17 May 2002

ASHTON COAL MINE PROJECT

DESCRIPTION OF PROPOSED DIVERSION

OPTION 2

FIGURE 1 - OPT 2

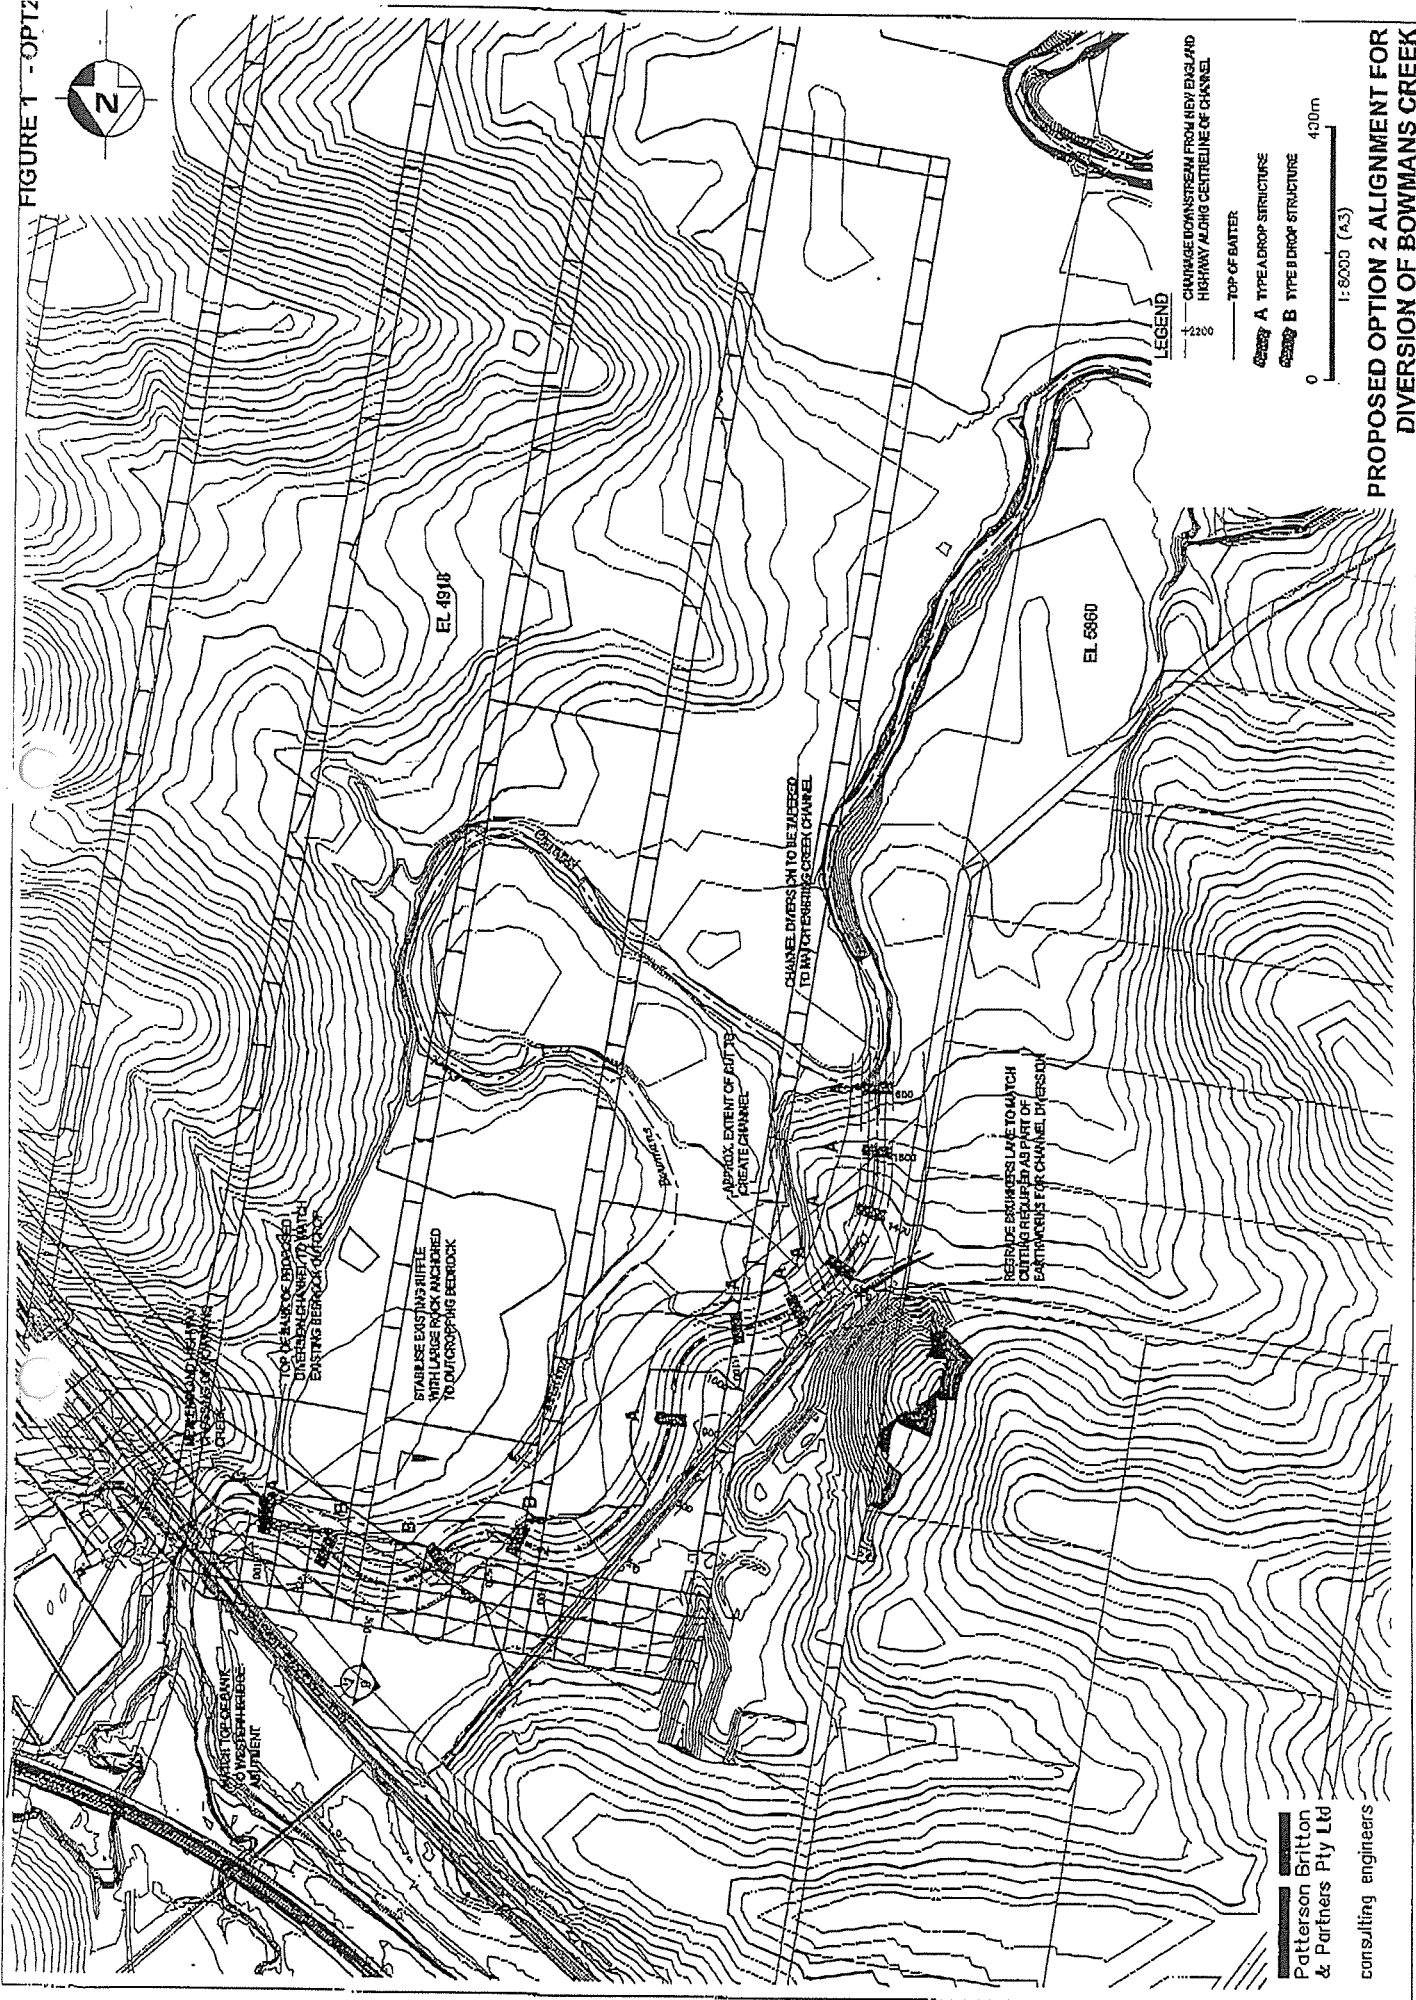
The proposed alternative for diversion of Bowmans Creek downstream of the New England Highway bridge crossing is shown in **Figure 1**. This alternative (referred to as Option 2) has an overall length of 1.5 km and commences at the existing riffle located about 100 metres downstream of the bridge. As described in the EIS, this riffle is characterised by exposed bedrock across part of the channel bed and along the eastern bank.

The first 1400 m of the diversion proposed as Option 2, follows the same alignment as presented in the EIS as Option 1. Beyond Chainage 1400, the diversion would be re-connected to the existing Bowmans Creek channel about 150 m upstream of the Department of Land and Water Conservation's (DLWC) stream gauging station (Gauge No. 210130). The adoption of the alignment presented for Option 2 would result in a one kilometre reduction in the length of the diversion originally proposed in the EIS (i.e. Option 1). The proposed project timeline showing construction, mining, and post mining activities is included as **Attachment 1**.

The proposed bed profile for Option 2 is shown in **Figure 2**. A minimum of 11 drop structures are proposed, with the first five of these corresponding to the locations originally proposed for Option 1. In this regard, the position of the drop structure proposed at Chainage 900 (refer **Figure 1**) is considered to be important as it is likely to be the first opportunity downstream from the start of the diversion to install a drop structure within bedrock. This drop structure needs to be maintained at this location and at the specified elevation to minimise any potential for a 'head-cut' along the channel reach extending upstream to the start of the diversion. A further six drop structures are to be located over the remaining length of the diversion (refer **Figure 2**). Each of these would typically be 120 metres apart, with average bed slopes of 1 (V) in 1000 (H) between successive drops.

Both the proposed diversion and the majority of the existing Bowmans Creek channel downstream from the re-connection point, are outside the theoretical limit of subsidence. Only the bend in Bowmans Creek just south of the large oxbow (refer **Figure 1**) would experience subsidence. Approximately 600 metres of the existing creek would potentially be impacted by subsidence. If all four seams are mined, modeling shows that the channel could experience subsidence of up to 0.9 m.

FIGURE 2

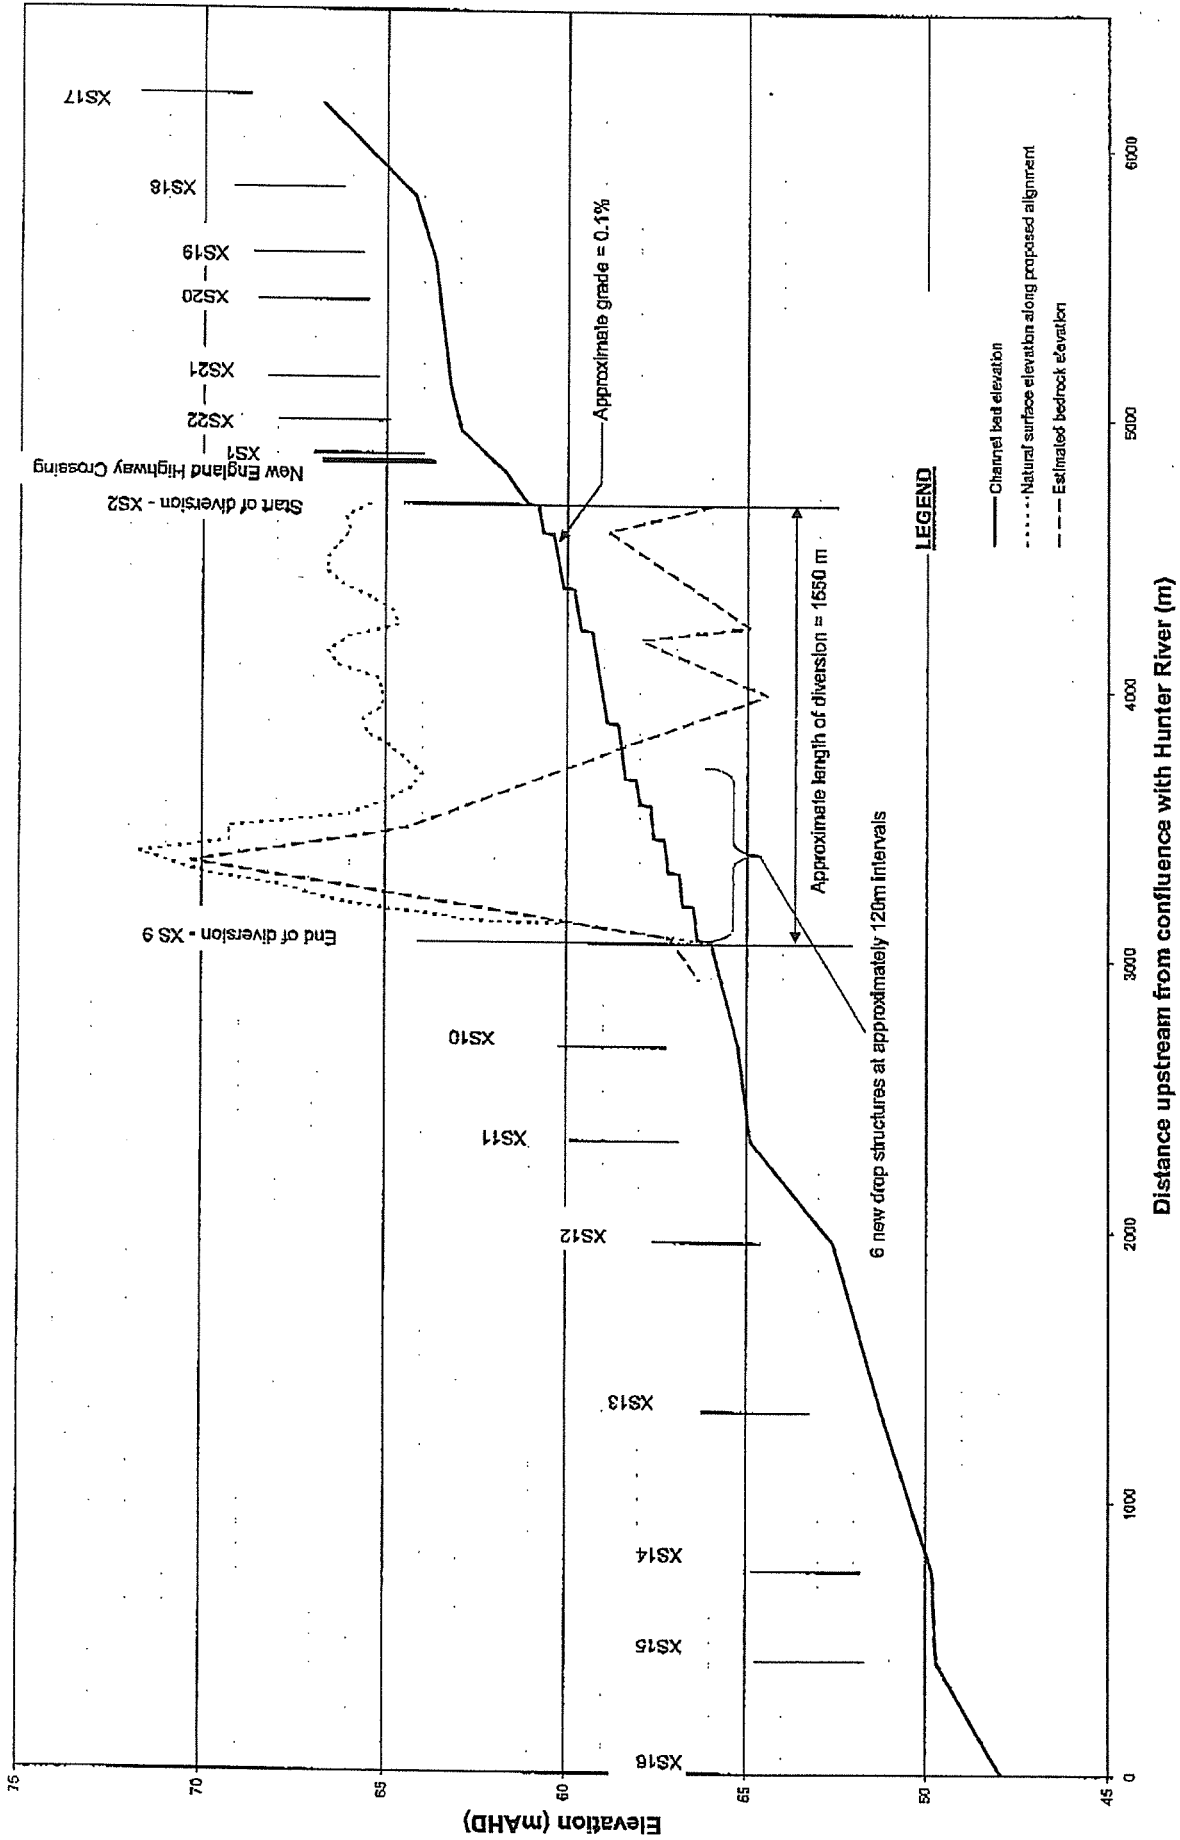
The Option 2 diversion is required to achieve a 5.1 m drop in elevation over a channel length of 1.5 km. This compares to the Option 1 diversion which provided a 5.8 m drop over 2.4 km. Fish passage via the Rutherford et. al (2000) design parameters can be achieved by the use of 11 drop structures, as shown in **Figures 1 and 2**.

The bed profile for the diversion should be compared with the two natural steep graded sections in the existing creek line located between XS1 and XS2, and between XS11 and XS12 (refer to **Figure 2**). In these areas, fish are required to climb 2.5 m over 200 m via a series of short riffle-pond sections. That is, the Option 2 diversion will have an average gradient one quarter that of the two natural steeply graded sections of the existing creek, with riffle-pond segments similar to or better than these creek sections.

TYPICAL DETAILS OF 'TYPE A' DROP STRUCTURE

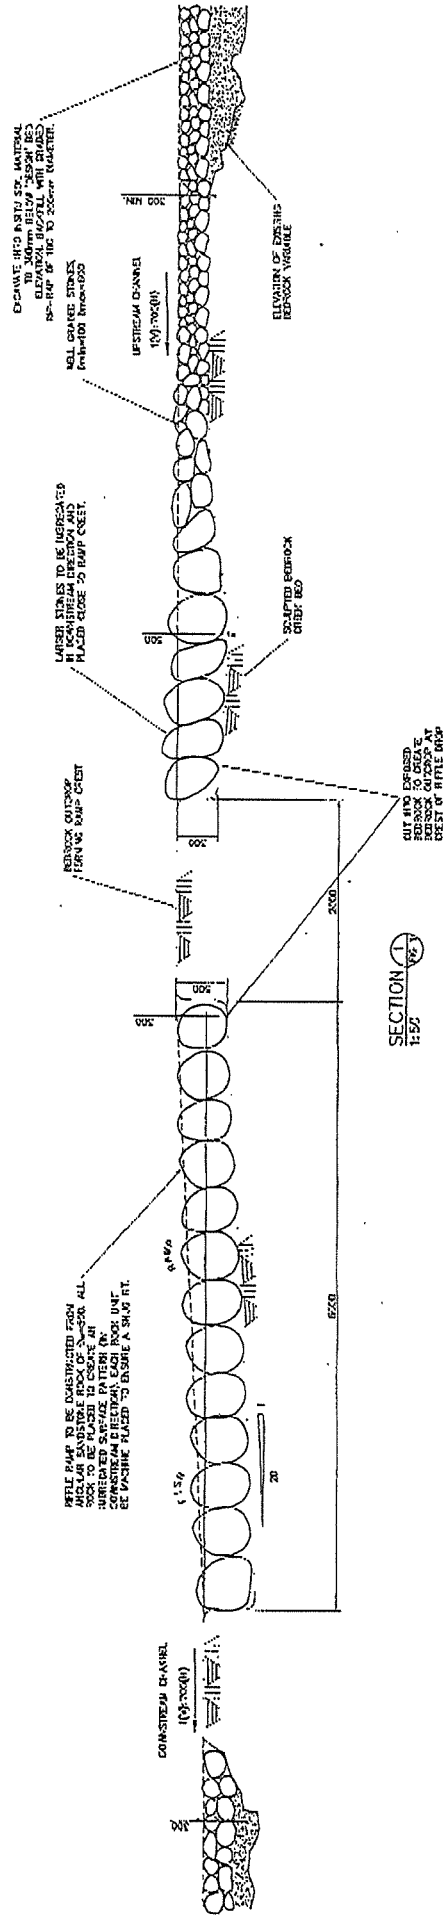
All drop structures would be constructed with a maximum drop of 300 mm, as detailed in the EIS. They would be constructed in accordance with the Type 'A' or Type 'B' concept designs presented within the written response to government agency comments on the EIS (refer **Figures 3 and 4**). These designs are in accordance with guidelines specified in the *'Rehabilitation Manual for Australian Streams'* (Rutherford et.al, 2000).
